Final Environmental Statement

related to the operation of
Limerick Generating Station,
Units 1 and 2

Docket Nos. 50-352 and 50-353

NUREG-0974

Figure 5.4g Probability distribution of cost of mitigation measures

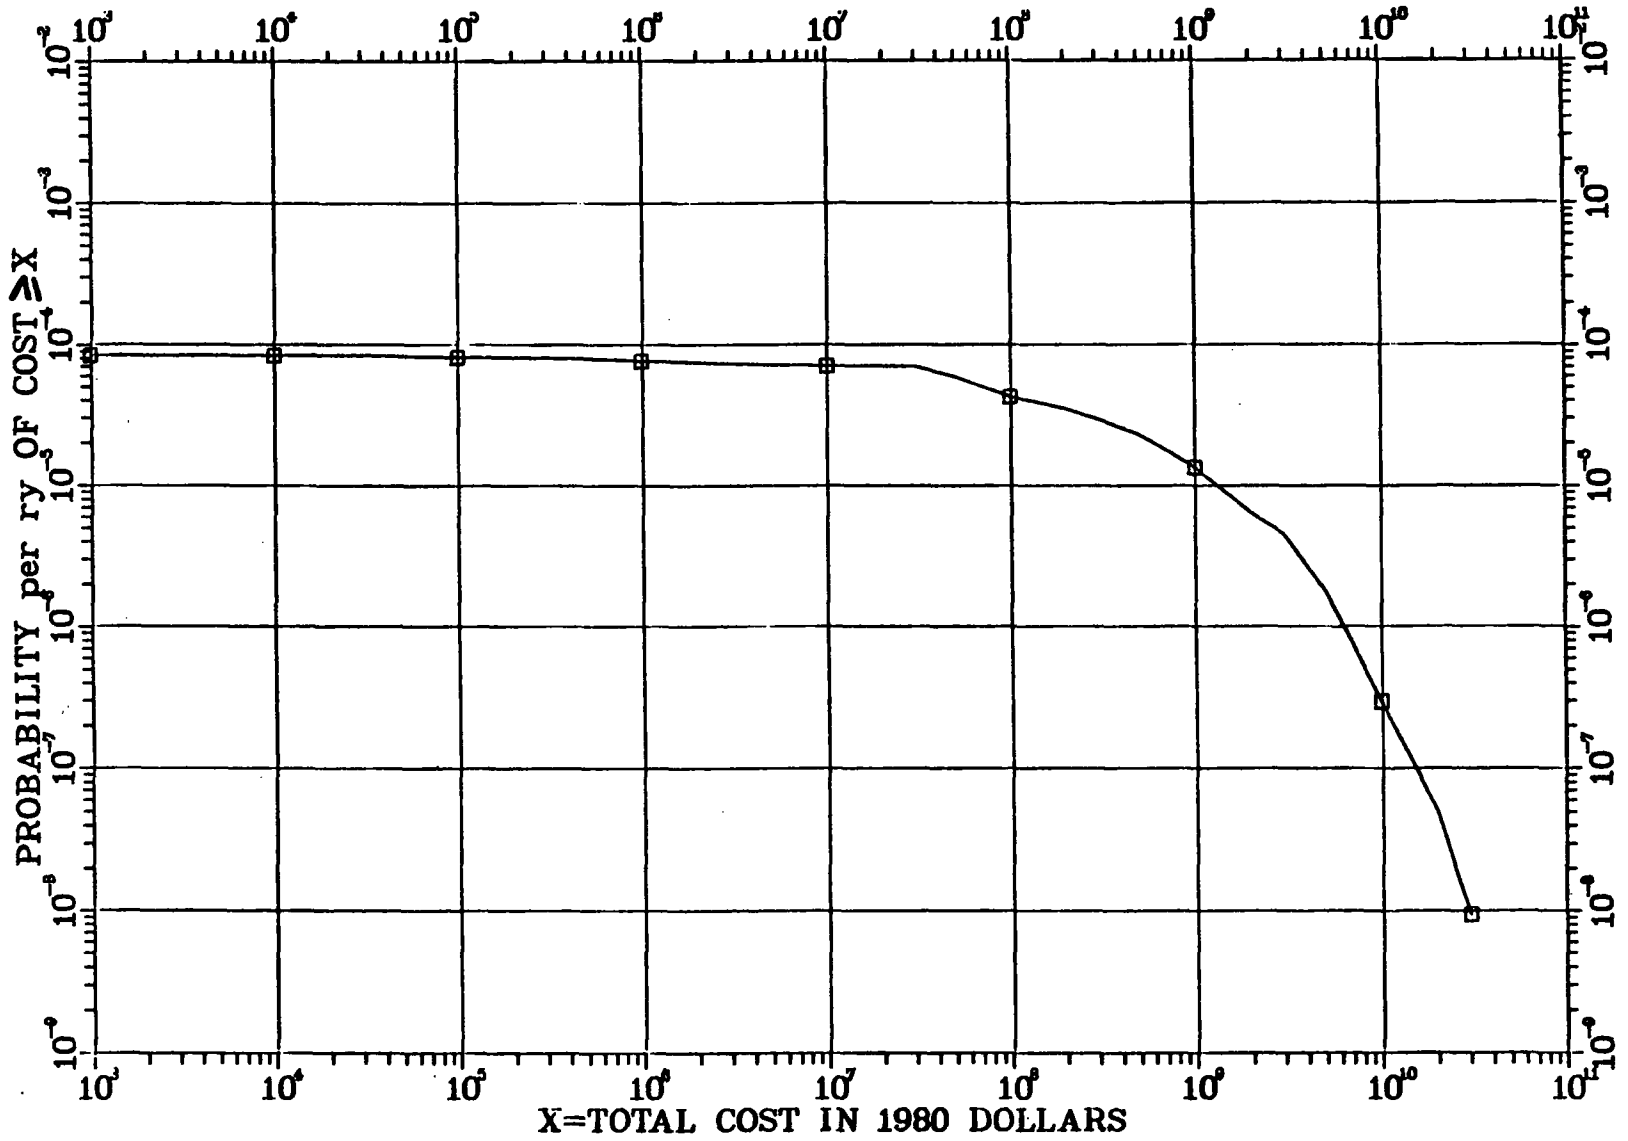
"The results shown are more severe than presented in the LGS SARA. This is due to the higher frequencies, higher release fractions, and more pessimistic emergency response. The major difference is in the CCDF for early fatalities (Figure 5.4e) which lies above the upper

Figures 5.4b to 5.4g and Table 5.11g: The results shown are more severe than presented in the LGS SARA. This is due to the higher frequencies, higher release fractions, and more pessimistic emergency response. The major difference is in the CCDF for early fatalities (Figure 5.4a) which lies above the upper 95% curve from SARA. The represented upper confidence levels (cross hatched areas) are not substantiated and are unprecedented for any assessment of risk. It is difficult to believe that these are plausible outcomes at any but the most extreme (much greater than 99%) confidence levels.

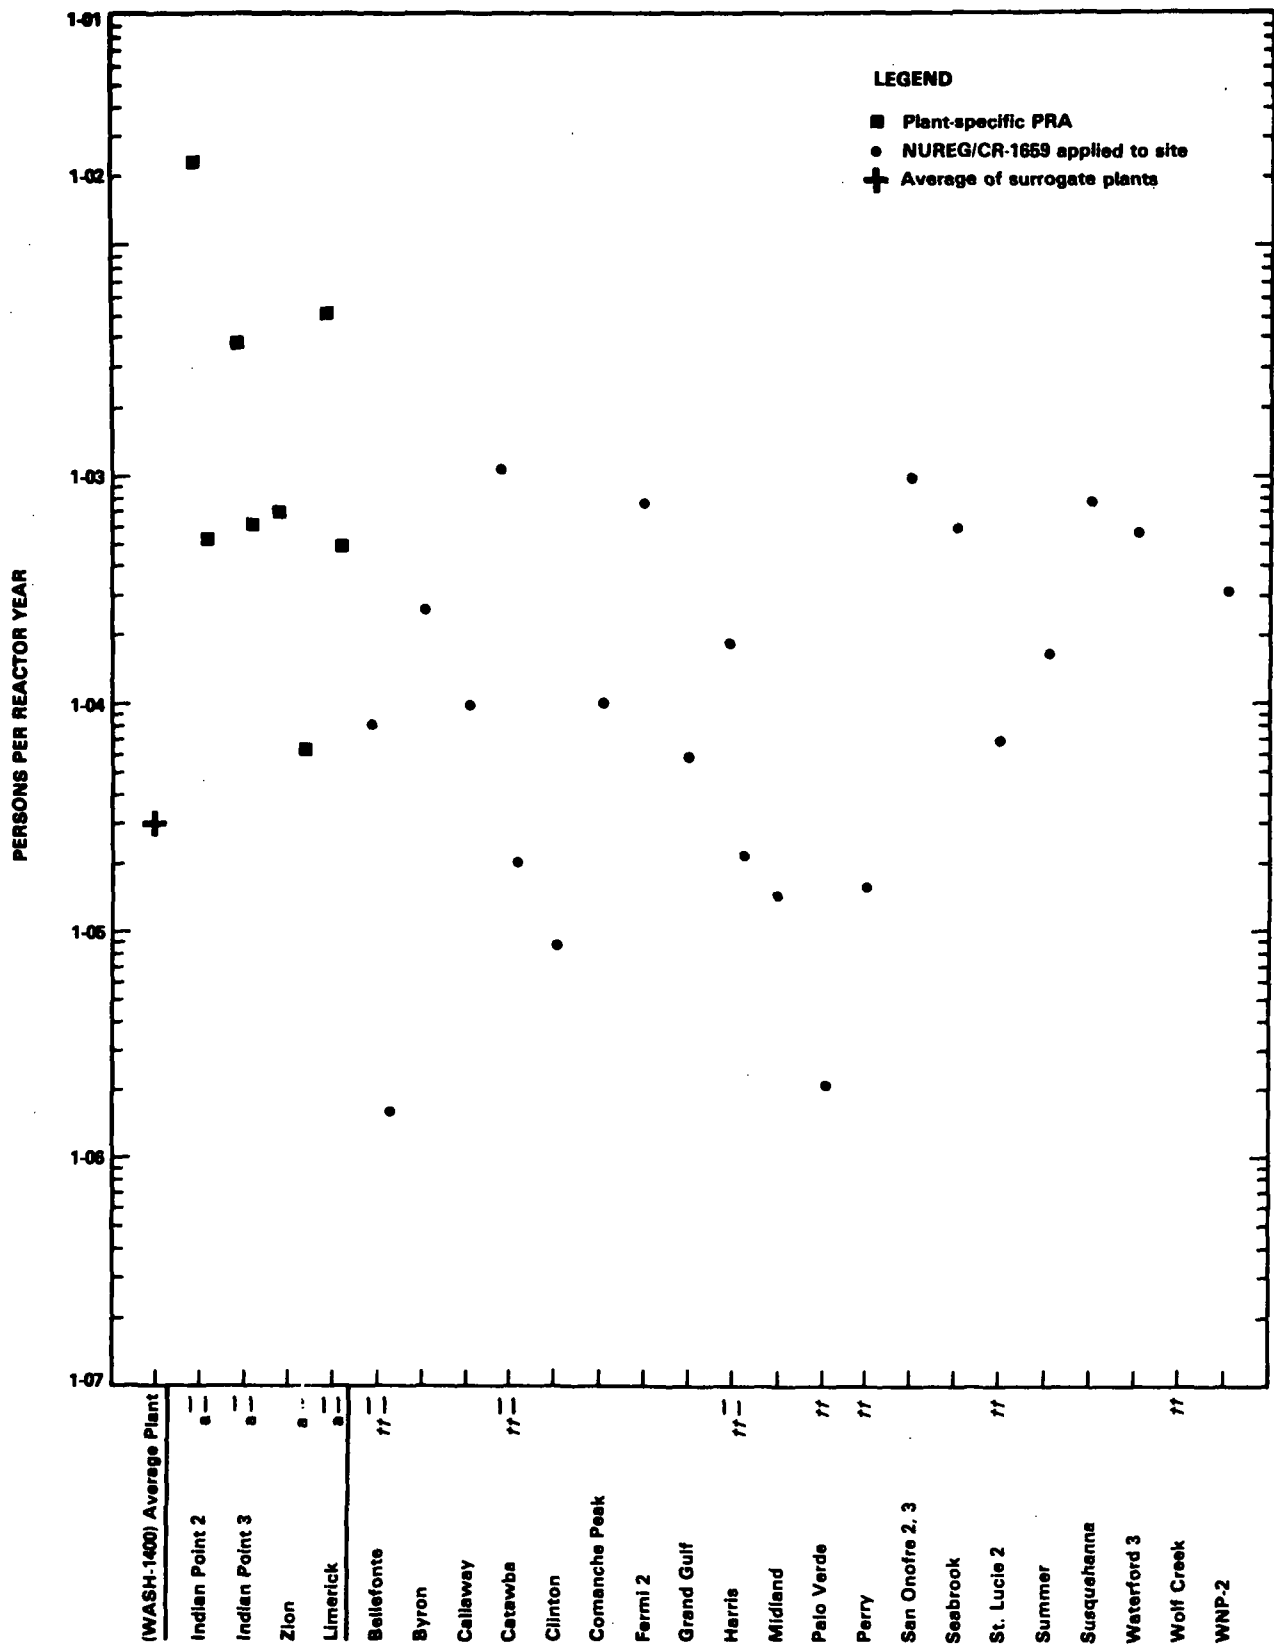
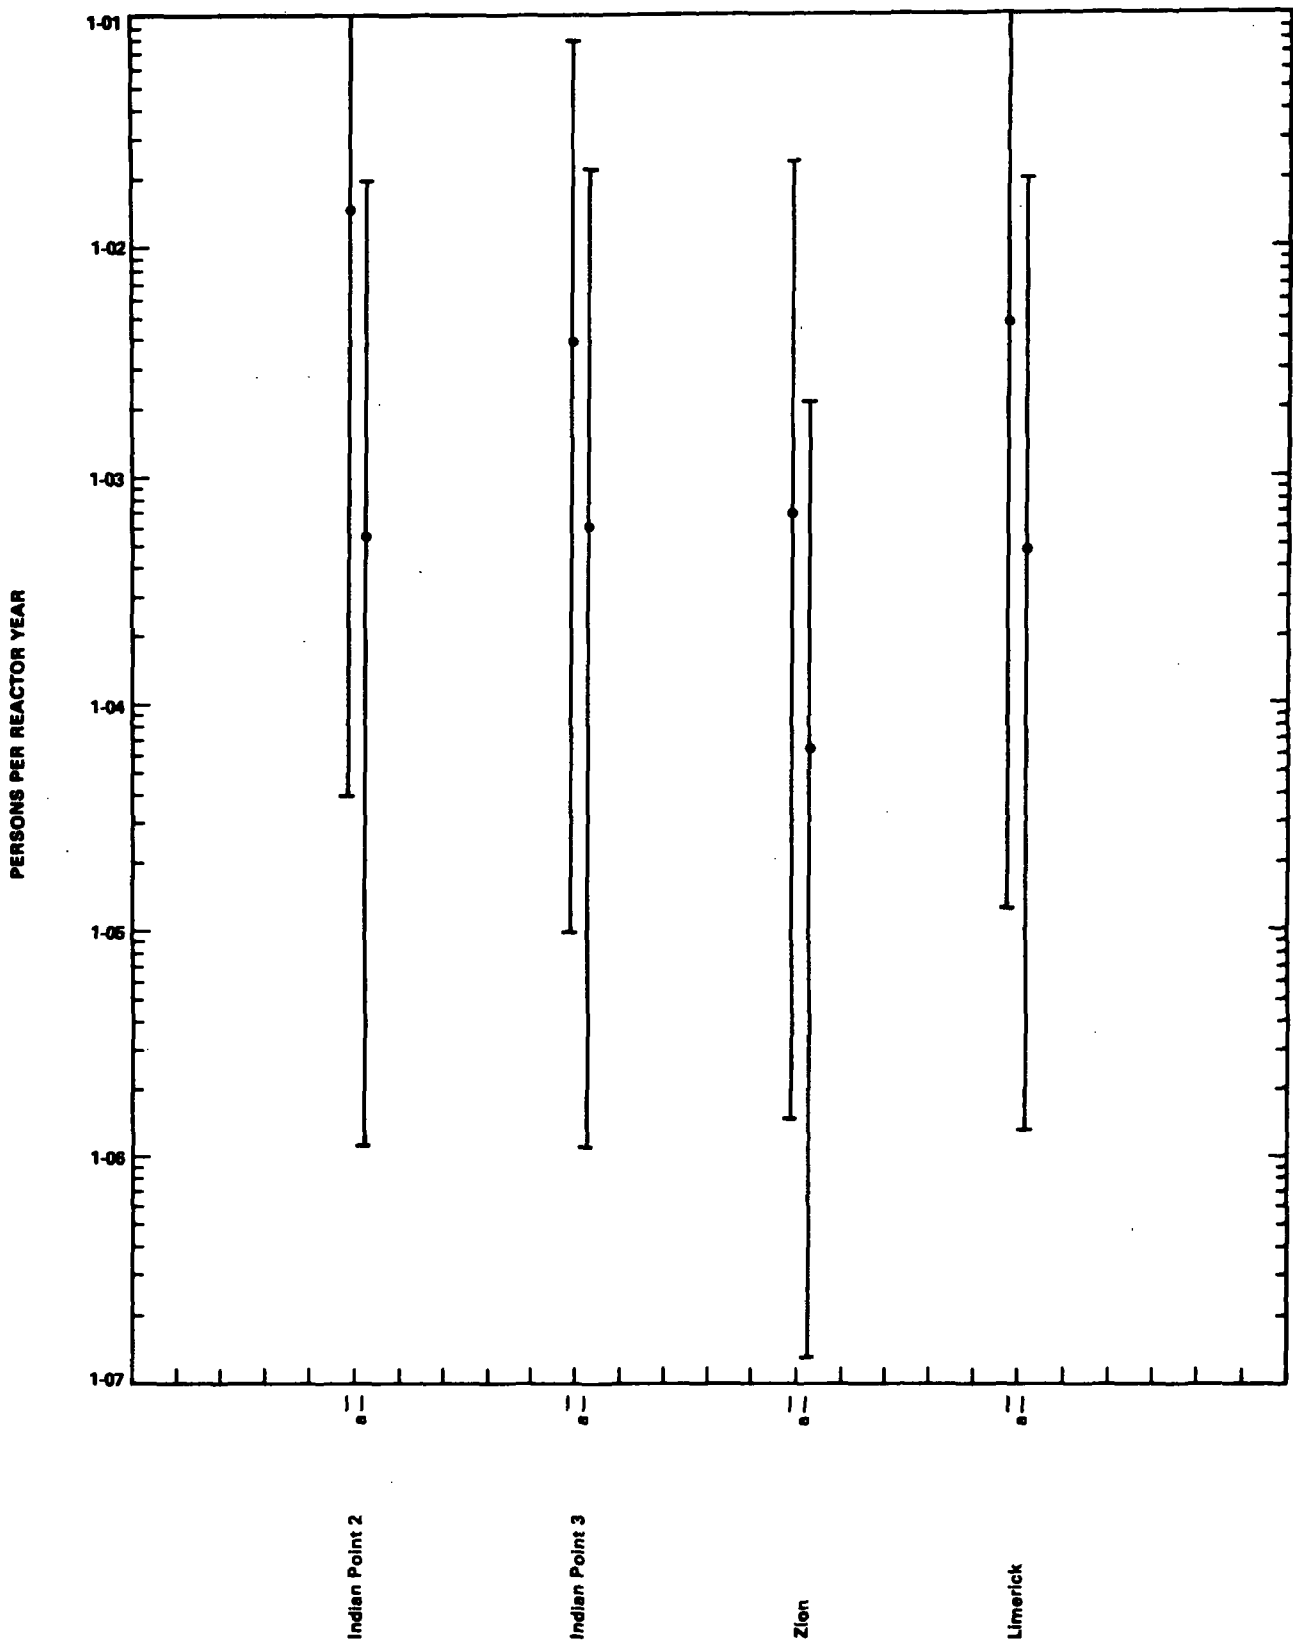
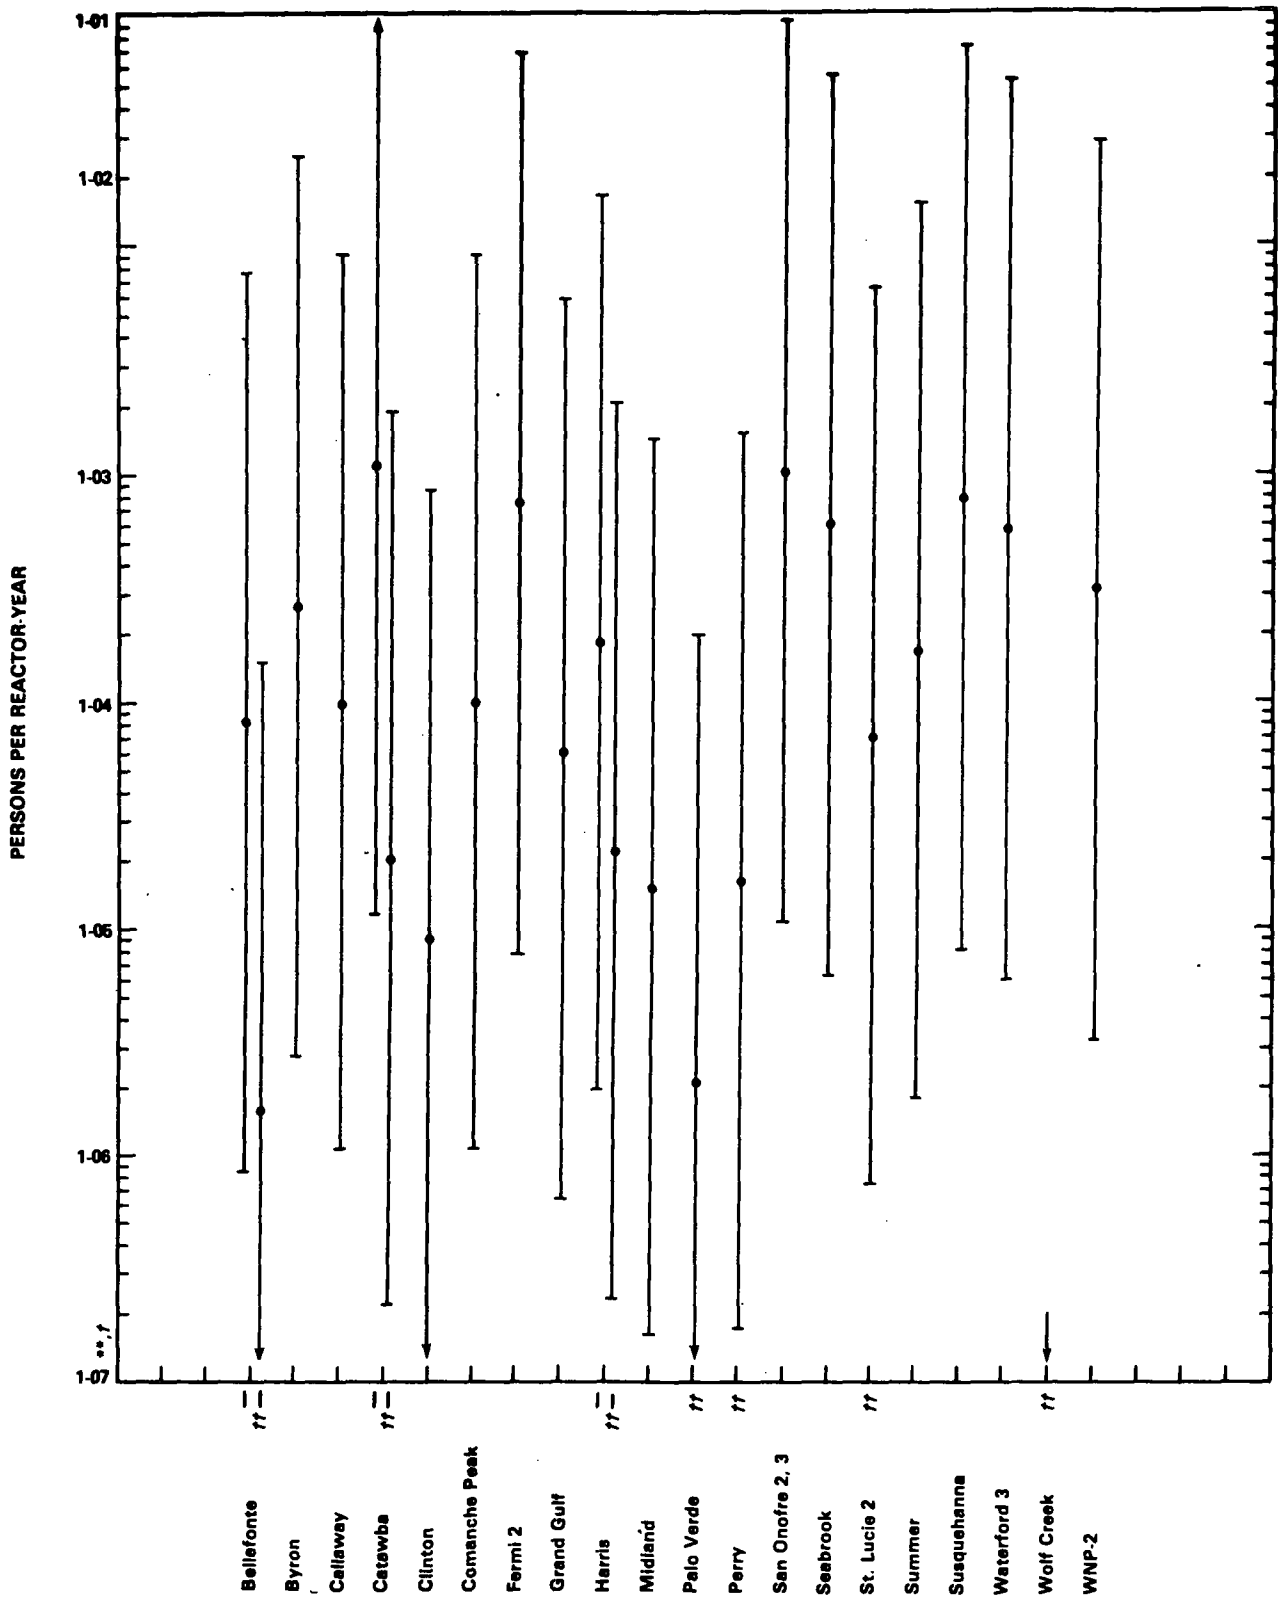
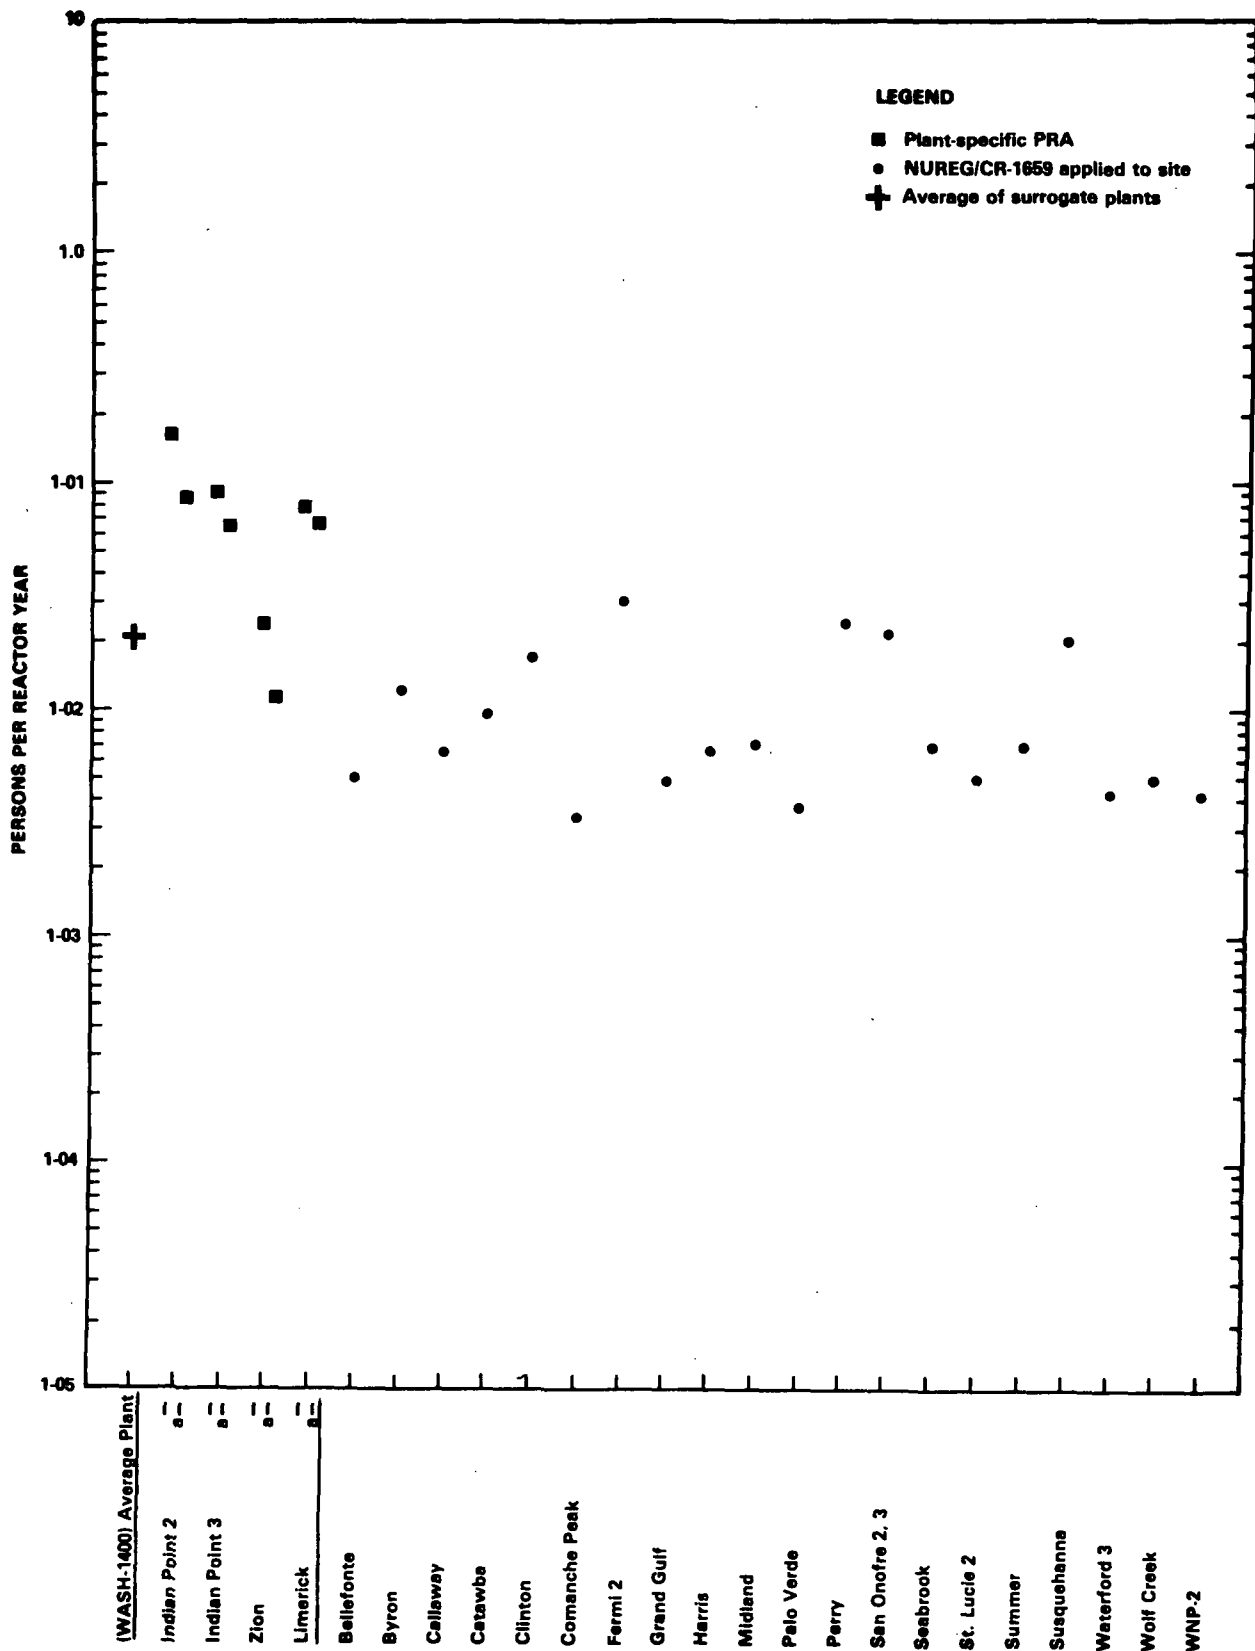
Figures 5.4n, o, p, q, r: The uncertainty bounds, contradict the text on page 5-54, which states that "the risk uncertainty bounds could be well over a factor of 10, but not as large as a factor of 100. Within these uncertainty bounds, however, the uncertainties associated with the probability-integrated values of consequences (the risks) are likely to be less. . .". No explanation is provided of what the uncertainty bounds represent. They appear to be an arbitrary factor of 100 in all cases. It is expected that the point estimate represents something greater than a 50% confidence level and may be greater than the 90% confidence level in some cases. It is believed that the weight of evidence supports a realistic estimate of risk considerably lower than the DES values and that the DES point estimates are much nearer the upper estimate than the median.
